**Rezoning Application:** PD 23-0994  
**Zoning Hearing Master Date:** March 25, 2024  
**BOCC Land Use Meeting Date:** May 7, 2024

**Hillsborough  
County Florida**

Development Services Department

## AGENCY REVIEW COMMENT SHEET

## 8.0 PROPOSED SITE PLAN (FULL)

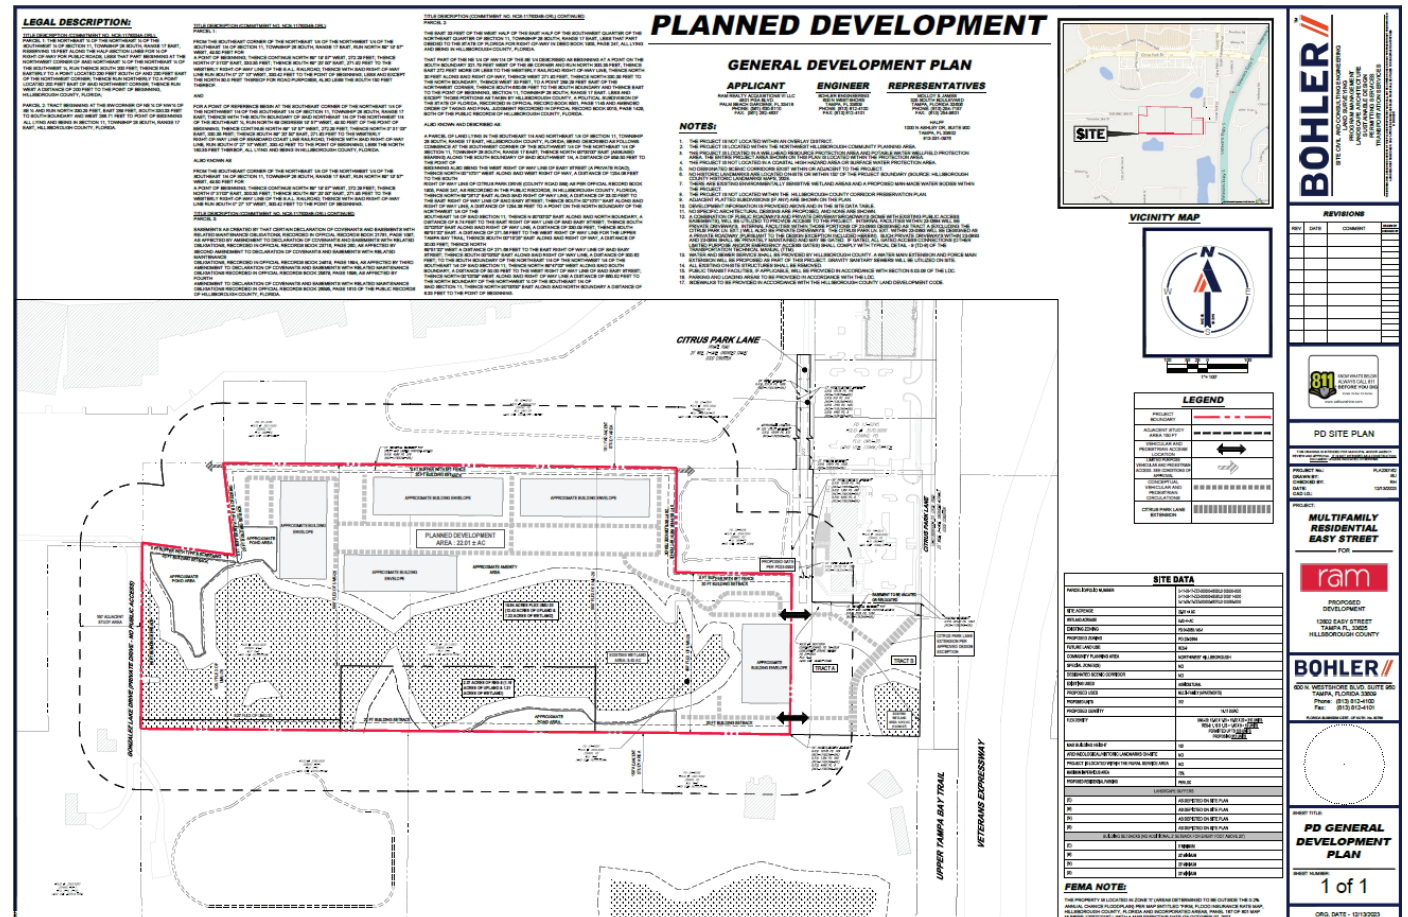
Prior to PD Site Plan Certification, the developer shall revise the PD Option 2 site plan to:

1. Modify Site Note 17 to add the statement “or as otherwise required within the zoning conditions” to the end of the note.
2. Revise the plan to show the existing driveway connections along the eastern project boundary and label as “Existing Access – To Be Removed”.
3. Add to labels on applicable adjacent property to the south as follows “Concurrent Zoning Review: PD 24-0031” and correct incorrect references to 04-0058 (staff notes the most recent modification for that PD is 07-0802);
4. Show and label the Upper Tampa Bay Trail;
5. Add location of required ADA-compliant trail connections and crosswalks as shown below. Label the two connections as follows: “Proposed Crosswalk #1 – See Conditions of Approval”, “Proposed Trail Connection #1 – See Conditions of Approval”, “Proposed Crosswalk #2 – See Conditions of Approval”, and “Proposed Trail Connection #2 – See Conditions of Approval”.

PD 23-0993 & PD 23-0994 & PD 24-0031  
Conceptual Location of Proposed Ramp Connection to Upper Tampa Bay Trail

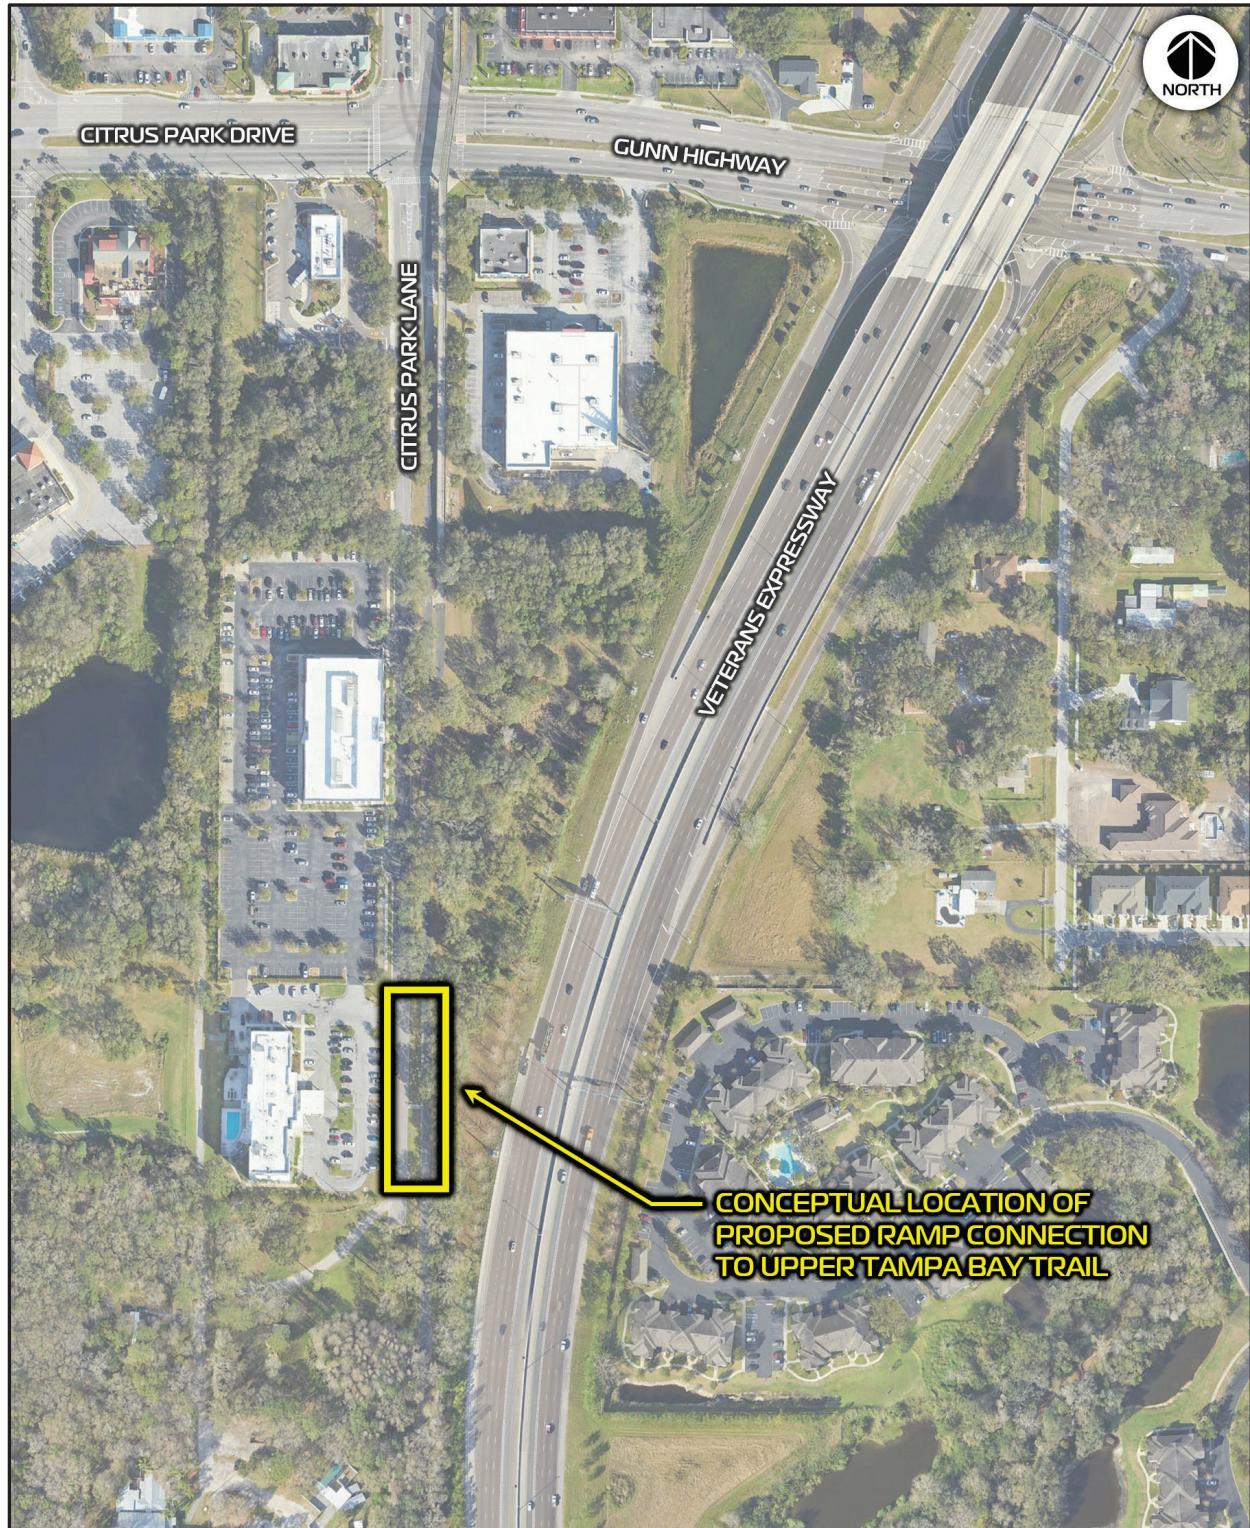
As alternative mitigation and to enhance safety along the roadway, the developer is proposing to construct a connection between the existing sidewalk system on the west side of Citrus Park Ln. and the UTBT, as generally shown on the PD site plan. The pedestrian crosswalk may occur at (or shall otherwise be in the general vicinity of) the existing staircase/connection to the UTBT located east of folio 3609.0000 unless otherwise necessary to meet vehicular sight distance standards to the newly constructed Citrus Park Ln. Extension.

The trail connection (which may be a new connection or a modification of the existing staircase connection) shall occur in whatever location is necessary to obtain approval and achieve a design which meets County and Americans with Disabilities Act (ADA) standards. This shall require the developer to install curb ramps on both the east and west sides of Citrus Park Ln. (including within a portion of folio 3609.0000). All of these required improvements are outside of the subject PD.

FIGURE 1  
Intersection Improvements

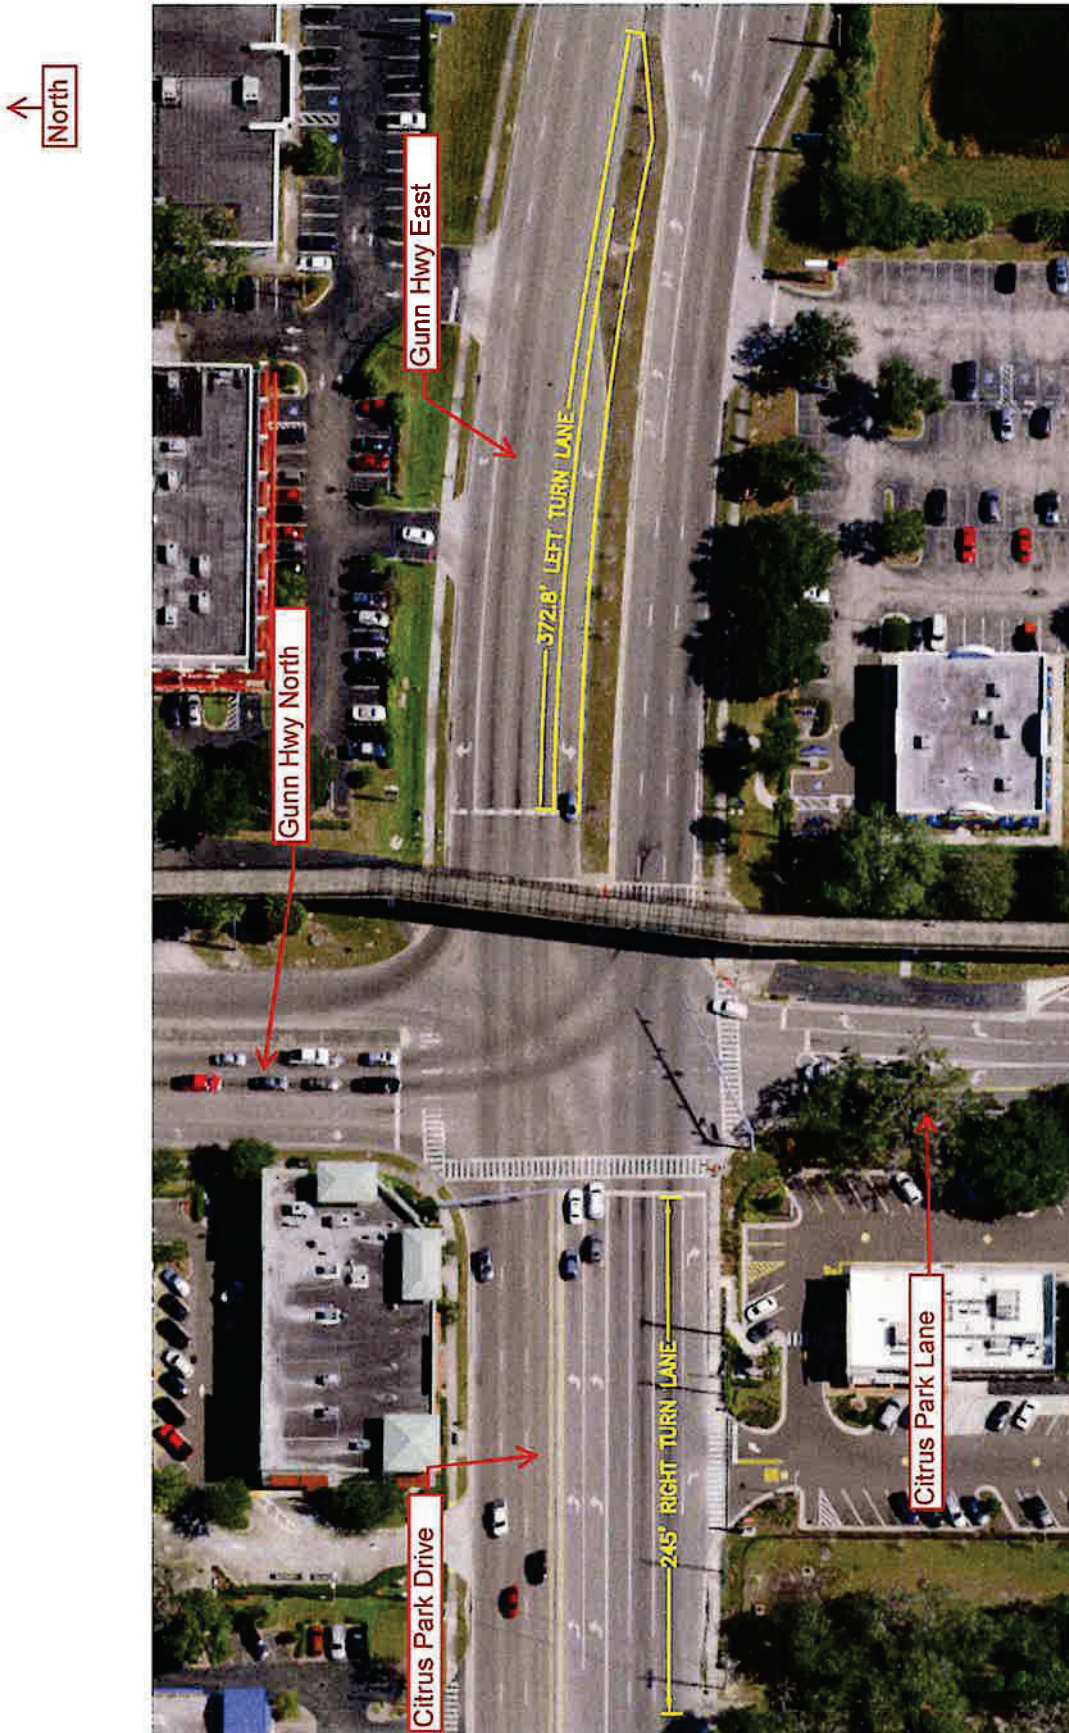
The existing westbound left turn lane is approximately 230 feet. In conjunction with the rezoning of these properties, the developers propose to extend the existing turn lane to approximately 372 feet, as shown in Figure 1.

As shown in Figure 1, the westbound left turn lane can be extended to approximately 372 feet which accommodates the 95<sup>th</sup> percentile queue for both scenarios. The turn lane can not be extended due to the eastbound left turn lanes for the Veterans Expressway Ramps.

**FIGURE 1**

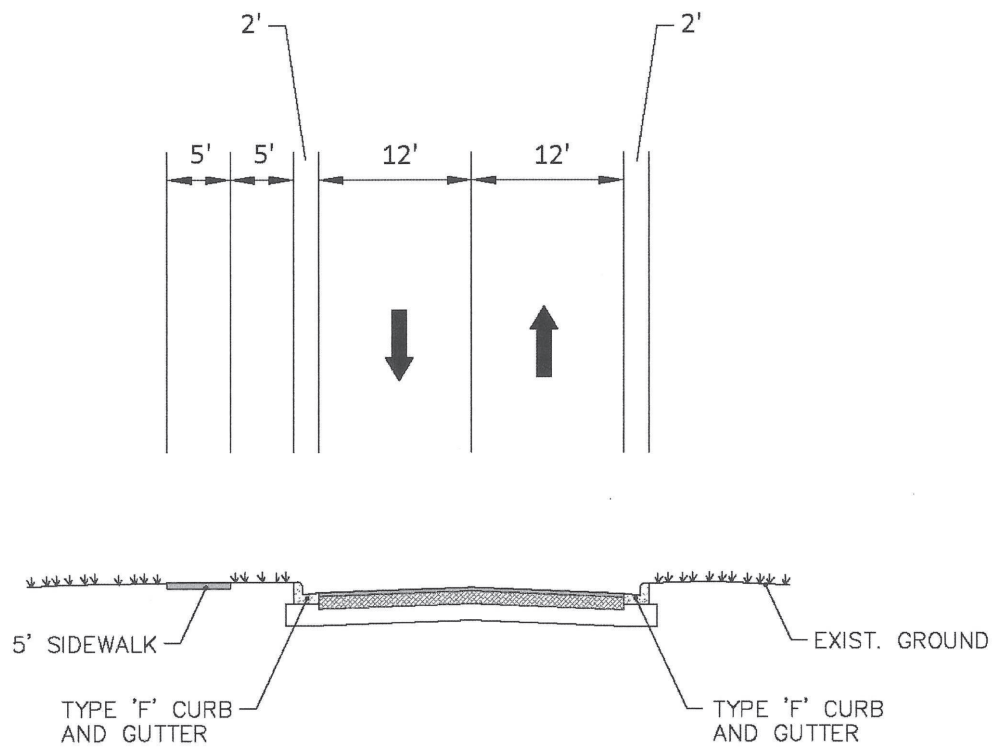
Figure 1 illustrates the proposed typical section for the extension of Citrus Park Lane from the current terminus through the project. The deviations and justifications for the variance to TS-4 are as follows:

- 1) Bike Lanes – The proposed section does not include the 7 foot buffer bike lanes. The justification for this is as follows:
  - a. There are no bike lanes on the existing roadway.
  - b. The roadway is adjacent to the ~~Suncoast Trail~~ which has connections to the trail.
- 2) Sidewalk – Sidewalk is proposed on the west side of the roadway. The justification and the deviation is as follows:
  - a. The existing roadway only has sidewalk on the west side of the roadway.
  - b. The ~~Suncoast Trail~~ is on the east side of the roadway.

**Approved with Conditions:**

- 1) Subject to the clarifications contained on other pages herein this document.
- 2) This Design Exception shall apply to the following projects and entitlements:  
23-0993 (Option 2): No Entitlements  
23-0994: 312 Multifamily Apartments  
24-0031: 230 Multifamily Townhomes
- 3) Clarification that Upper Tampa Bay Trail connection shall include a crosswalk across Citrus Park Ln., as specified in the zoning conditions.
